Nice Bridge Bicycle/Pedestrian Draft Comment Letter

Re: TPB Expression of Preference for a Barrier-Separated Bicycle and Pedestrian Facility on the Replacement Governor Harry W. Nice Memorial Bridge

TO: Transportation Planning Board
FROM: Kanti Srikanth, Planning Director, Michael Farrell, Regional Transportation Planner
SUBJECT: Governor Harry W. Nice Memorial Bridge Bicycle and Pedestrian Facility Recommendation
DATE: September 19, 2018

Figure 1: Conceptual Design – Shared Lane ¹

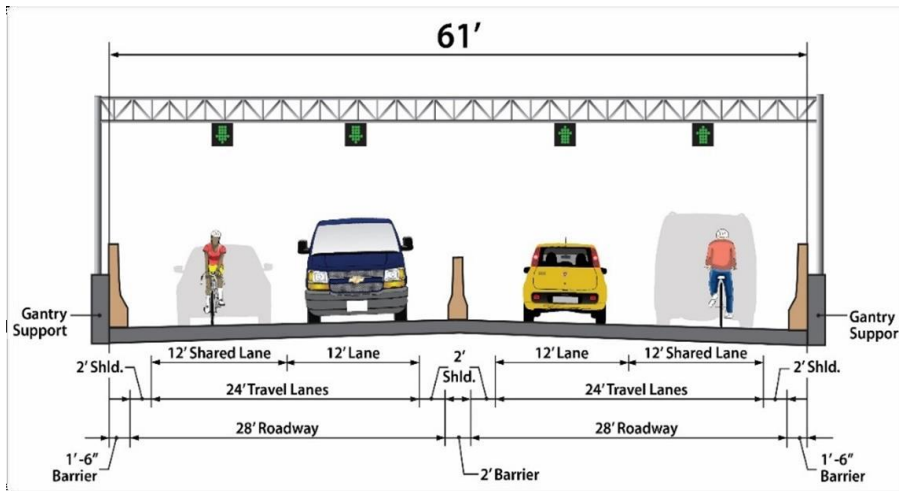
Both options for the Nice Bridge will feature four 12-foot travel lanes, and 2-foot shoulders. The proposed speed limit is 50 mph (same as the existing two-lane bridge). Under the shared lane option, bicyclists are to ride in middle of the travel lane (Figure 1).

With only 2-foot shoulders under consideration, the shared lane option would provide no accommodation for pedestrians, including any motorists that may seek safety outside the path of traffic in the event a car breaks down. As such a shared lane would preclude access to pedestrians seeking to cross the bridge. Conversely a barrier-protected side path would accommodate pedestrians and stranded motorists and could also serve as a temporary detour to maintain traffic flow during major maintenance or reconstruction.

Due to the high motorized vehicle speeds, the presence of trucks, and the steep grade, a shared lane alternative on the Nice Bridge would accommodate only the most fit and fearless of bicyclists. As a result, access to bicyclists will for practical purposes would be restricted.

2. The shared-lane option for bicyclists across the Nice Bridge, designed for high speed and relatively high traffic volumes would pose serious safety risks, and is not consistent with current best practice. It will be useable, if at all, by the most fit and fearless of bicyclists.

As you pursue further project planning and development, the TPB urges you to consider only designs that include a barrier-separated facility on the new bridge. The reasons for the TPB's position are as follows.

Figure 4: Recommended Minimum Shoulder on Rural Roadways ⁵

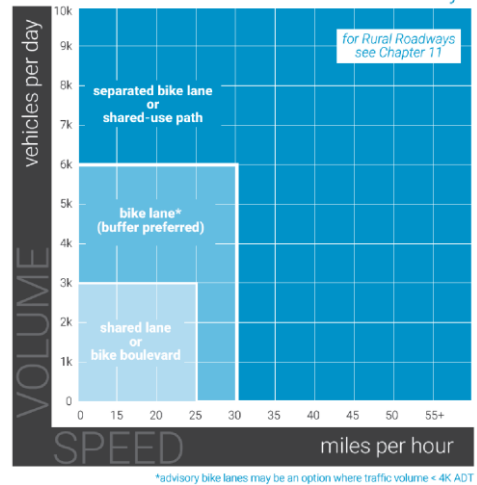
2. The 2012 (current) AASHTO Guide on Bicycle Facilities calls for barrier separation on any bridge greater than one-half mile in length, and at least 5 feet of separation or a crash-resistant barrier between a bike path and any high speed, high volume roadway.
3. It is TPB staff's understanding that the Draft 2018 AASHTO Guide on Bicycle Facilities calls for 5-foot shoulders on any rural road (Figure 4) with a speed limit greater than 45 mph and more than 6,000 vehicles per day.

The barrier-separated alternative design option under consideration for the Nice Bridge replacement in Maryland would merit the first two best practice guidance noted above but it would not meet the third guidance noted above. The shared lane alternative also under consideration would not meet any of the above three best practice standards.
